Well Name: SEMU	Well Location: T20S / R37E / SEC 24 / NESW / 32.5567436 / -103.2071124	County or Parish/State: LEA / NM
Well Number: 67	Type of Well: OIL WELL	Allottee or Tribe Name:
Lease Number: NMLC031620A	Unit or CA Name: SE MONUMENT - I. UPR PERM	Unit or CA Number: NMNM71041A
US Well Number: 300250624800S2	Operator: MAVERICK PERMIAN LLC

Sundry ID: 2880306

Type of Action: Plug and Abandonment

Procedure Description: Maverick Permian is respectfully submitting for your review the P&A plan for SEMU 67

PROPOSED WBD

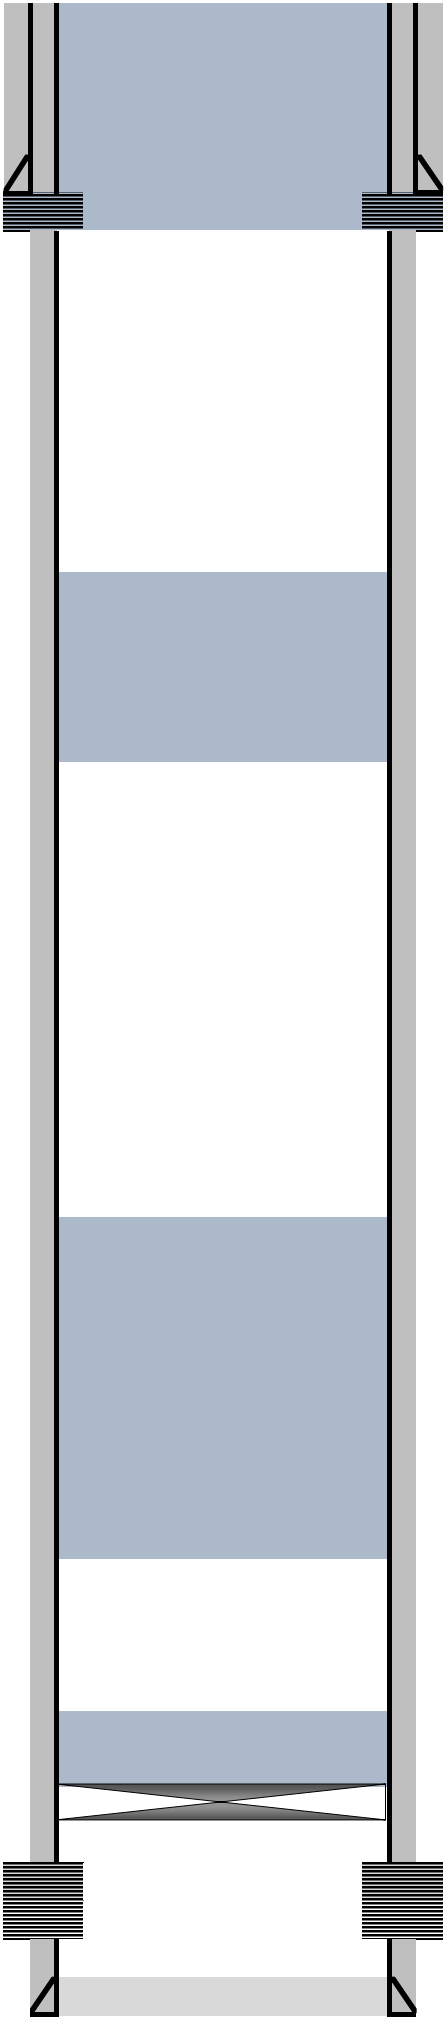
SURFACE PLUG

Perf 5 1/2" casing @ 423'

Attempt sq. DO NOT exceed 500 psi.

Spot 65 sx of Class C cement @ 423'

T.SALT & RUSTLER PLUG

Spot 45 sx of Class C cement @ 1,502'

B.SALT, YATES & 7 RIVERS PLUG

Spot 95 sx of Class C cement @ 3,016'

GRAYBURG & QUEEN PLUG

CIBP @ 3,558'

Spot 30 sx of Class C cement @ 3,558'

SURFACE PLUG
Spot 43 sx of Class C cement @ 423'
WOC 4 hrs. Verify at surface. See CBL
results if a perf and squeeze is needed.

T.SALT & RUSTLER PLUG
Spot 45 sx of Class C cement @ 1,502' WOC
4 hrs. Tag and record plug depth @ 1057'.

B.SALT, YATES & 7 RIVERS PLUG
Spot 95 sx of Class C cement @ 3,016' WOC
4 hrs. Tag and record plug depth @ 2077'.

GRAYBURG & QUEEN PLUG
CIBP @ 3712'
Run CBL from TOC to surface
Spot 33 sx of Class C cement @ 3,712' WOC 4
hrs. Tag and record plug depth @ 3393'.

PROPOSED WBD
10/27/2025

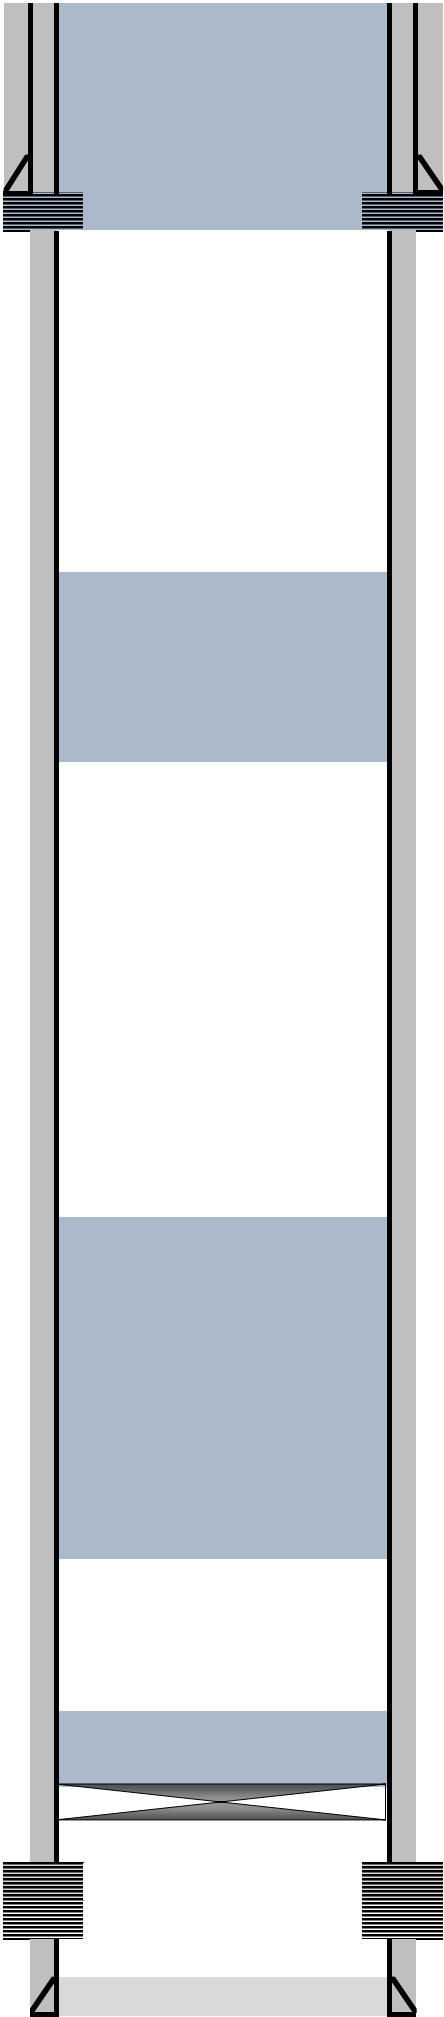
*Run CBL from CIBP to surface.

Submit results to BLM.
